APPENDIX J

HAZARDOUS, TOXIC AND RADIOLOGICAL WASTE (HTRW)

Figure 9. Area 8 Site Plan with Proposed Sampling Locations and Construction Elements.

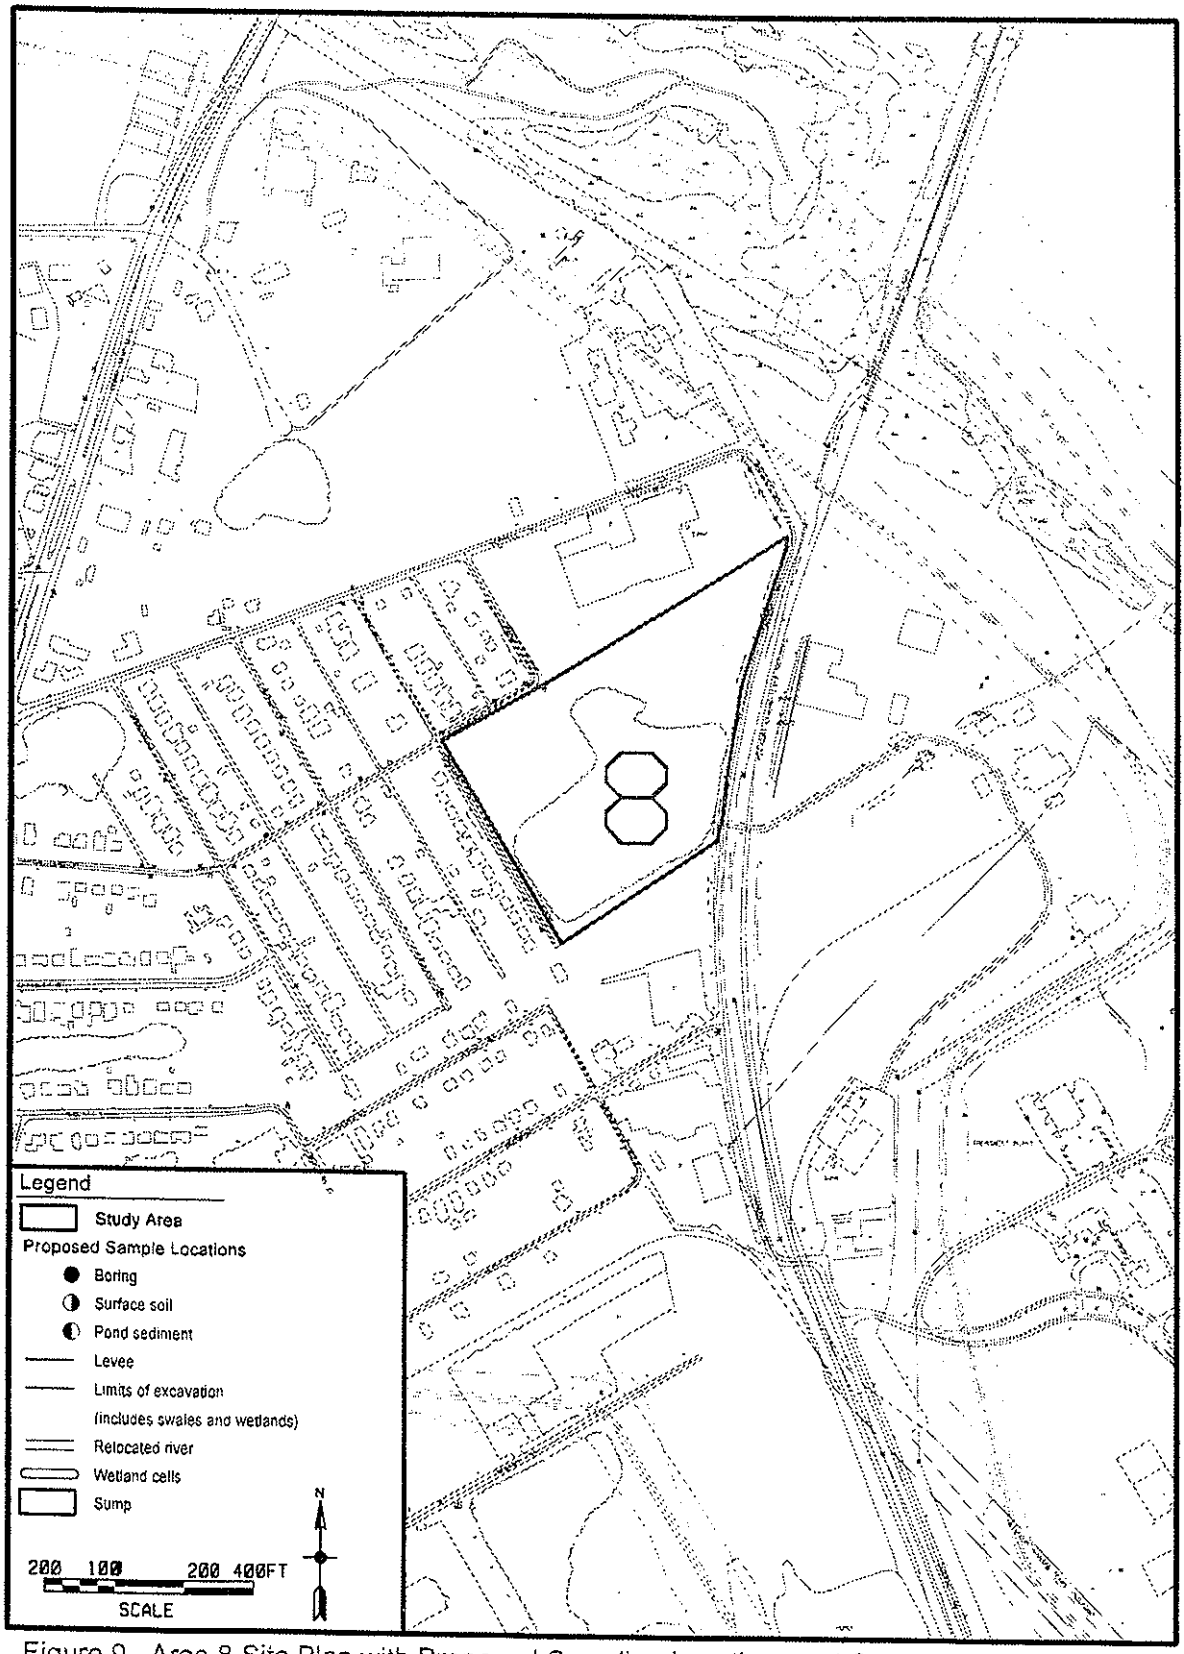
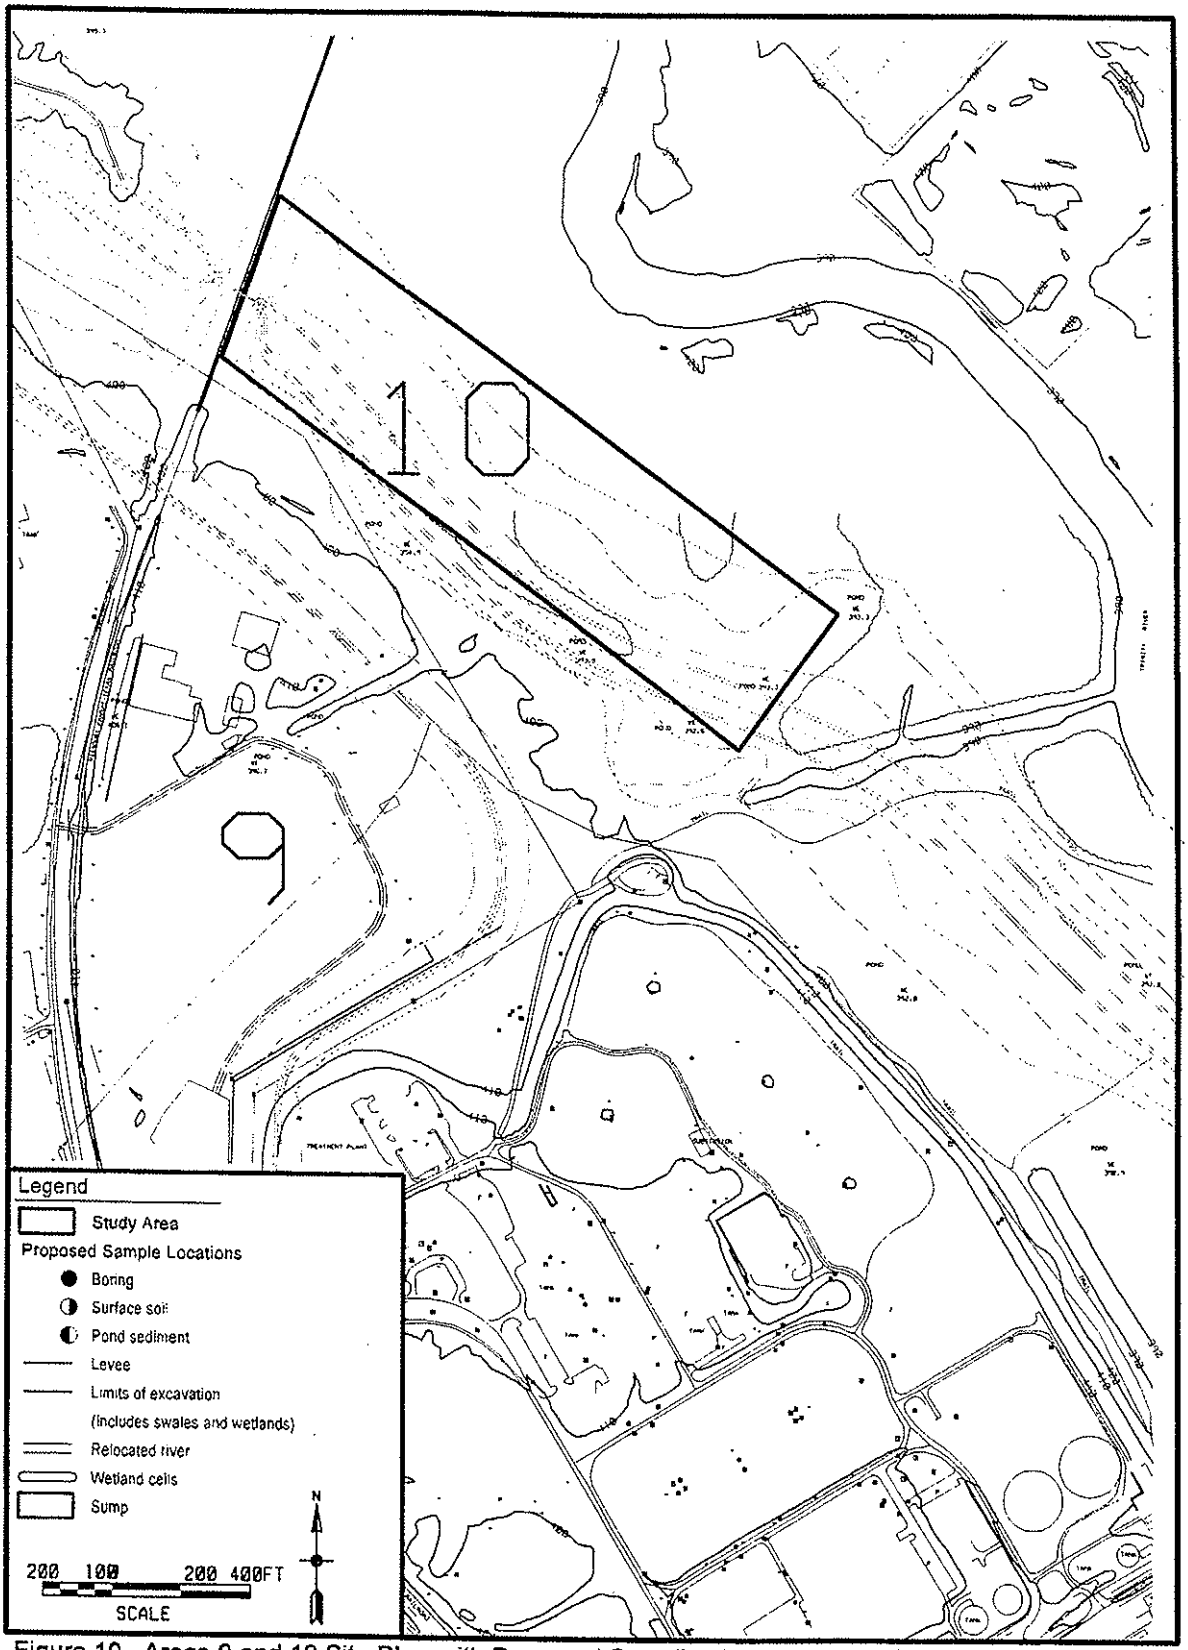
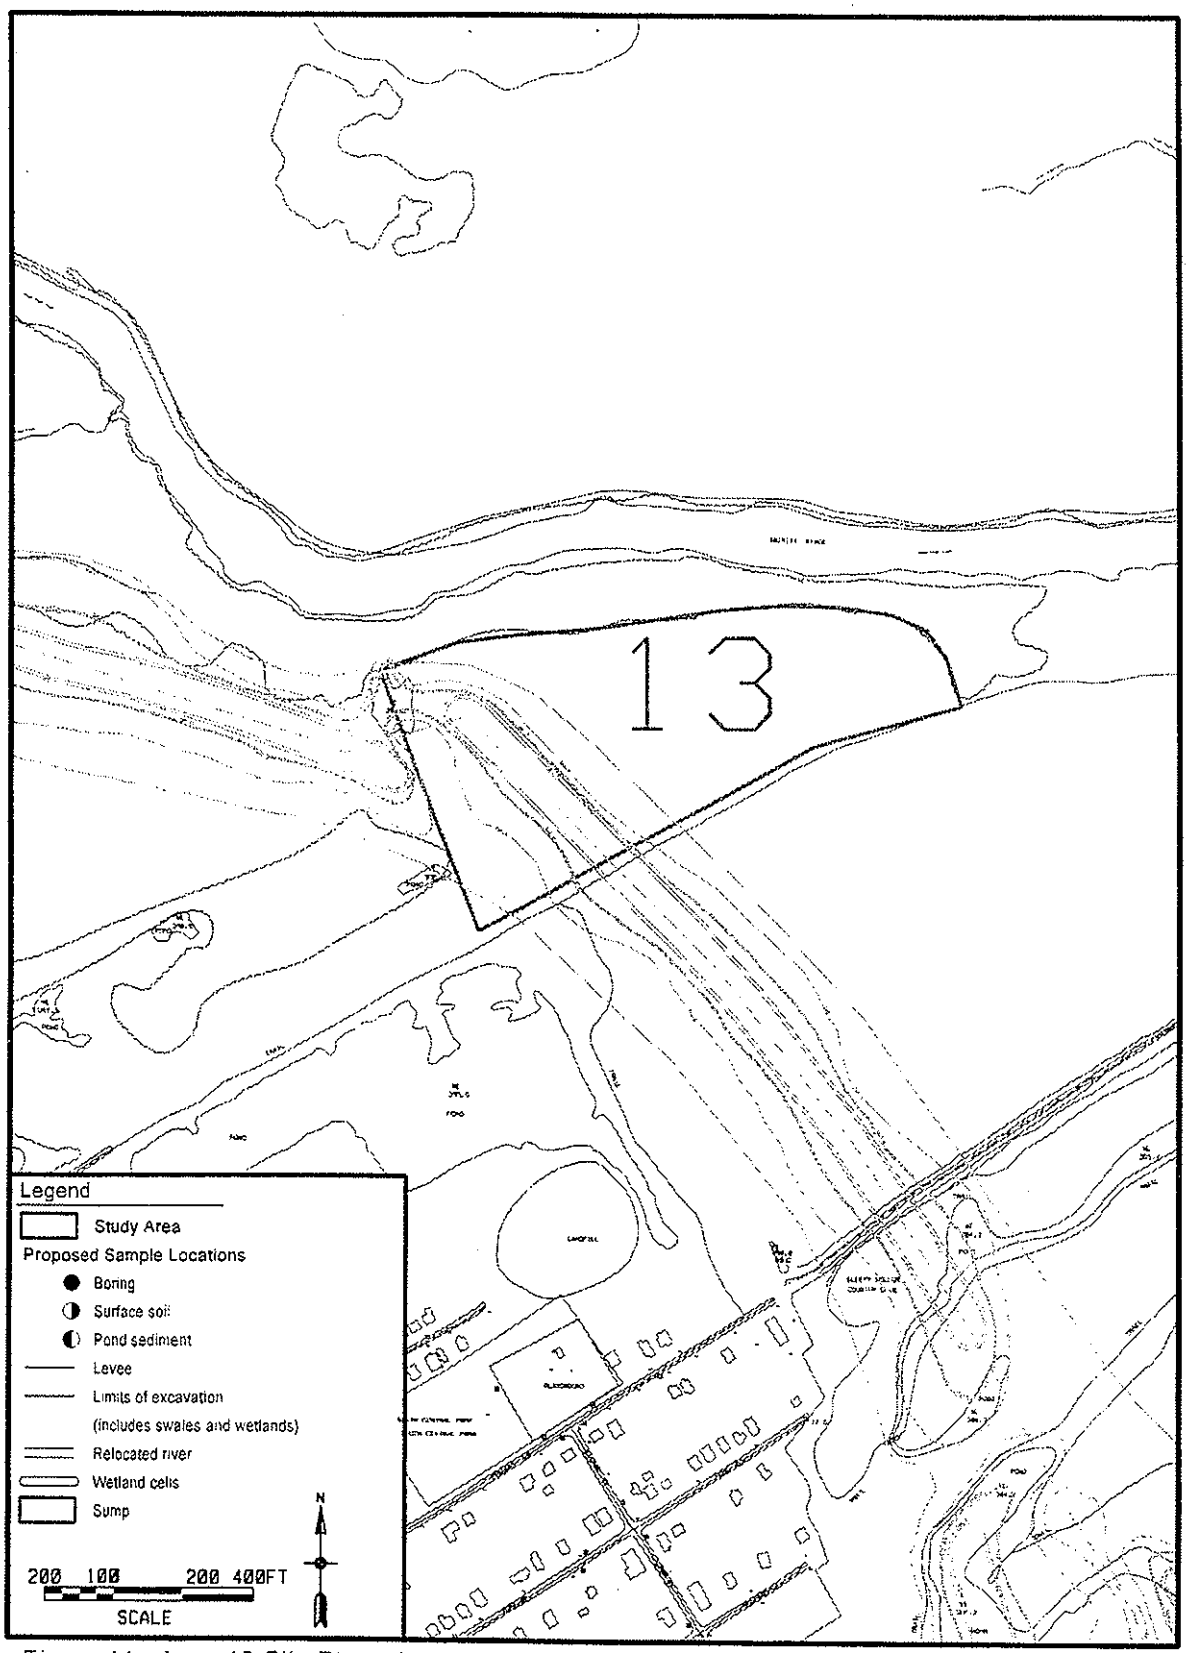
186. Appendix J, Figure 1 Area 1 through Figure 11 Area 13 are not clear and do not adequately show locations and addresses of borings made. The figures do not show borings taken from surface soil, swales, COWs, levees, sumps.

183. The locations of these areas are shown in figure 1, immediately prior to Section J-1, and in Section J-1 of Appendix J.

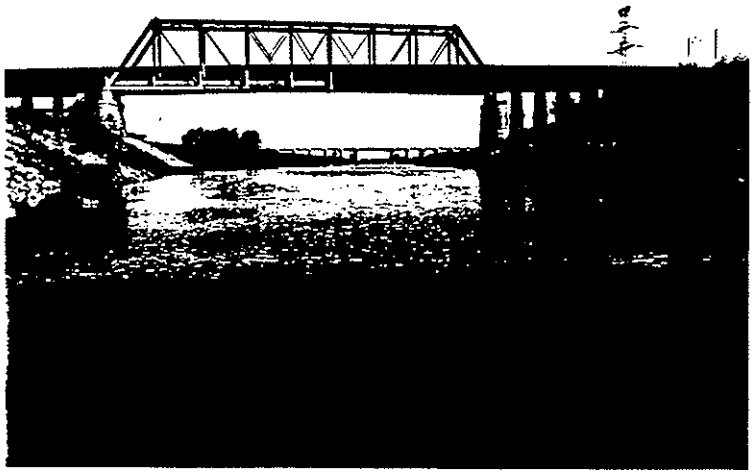
Cultural Resources section of the GRR/EIS and were omitted. The northern bridge (Photograph 1) on the edge of the project area represents an old (cf.) Pratt Through-Truss type railroad bridge (Comp and Jackson, 1977) previously used by the AT&SF RR (MAPSCO, 1992: 45) and has been abandoned alongside the DART rail bridge. There has been discussion of incorporating this bridge

88. The bridge is not proposed to be included in the project recreation plan.

Photograph 9. Unrecorded historic structure on the left bank of the river. Taken 6/13/98 9:45 AM.

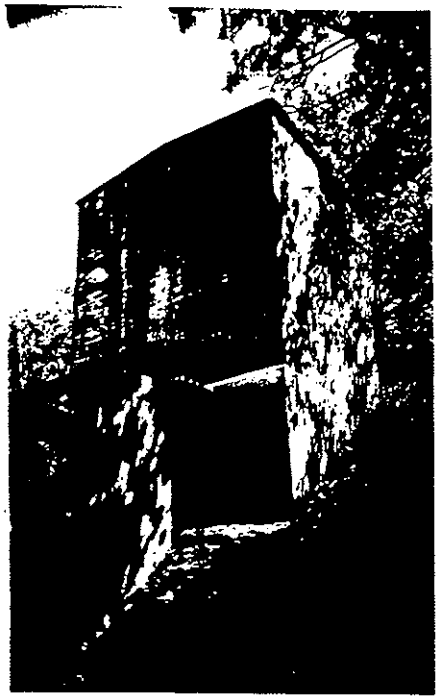
94. Descending the bottomland hardwood forest covered floodplain and river banks (Photograph 8) another historic structure (Photograph 9) that compares favorably to a pump station was observed on the left bank of the river. This potentially historic structure was not recorded in any previous surveys and exists in the vicinity of Sump 3, and north of the I-45 new channel and bridge. This site may also be impacted by the relocation of pipelines, utility lines, and easements and lies across from the CWWTP. This potentially historic site needs to be assessed and included in the Cultural Resources part of the EIS.

94. See response to comment #86 on page N - 95 regarding the assessments of this structure.

Photograph 14. The Rector street heron and egret rookery, June 1998.

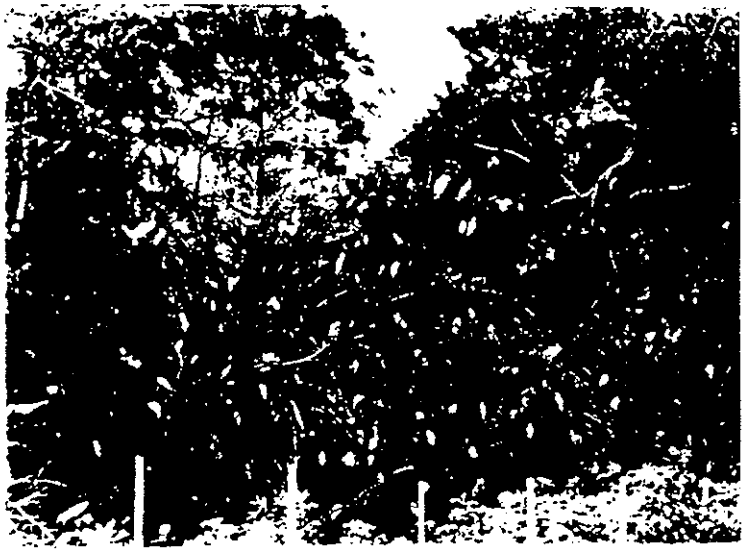
268. waterfowl, but none are listed, and makes no mention of the local avian populations such as the heron rookery on Rector Street at the east end and north side of Midwest Engines property (Photograph 14). One sentence in Appendix G mentions the rookery but no details towards the end. This rookery contains several hundred adult and young herons and egrets that was once larger with more birds (in 1992), but since DART built their facility and the present property owner has changed the amount of birds at the rookery is less, although still highly significant. To list a few of the rookery birds observed in two hours in June 1998 and photo documented: rare White ibis (Photograph 15), Black-crowned night herons, snowy egrets, cattle egrets, Great white egrets, Little blue herons and according to Appendix C the Cadillac Heights levee alignment will impact the rookery.

268. The rookery is well known and the project would not impact as currently proposed. See additional discussion to comment #18 on page N - 23.
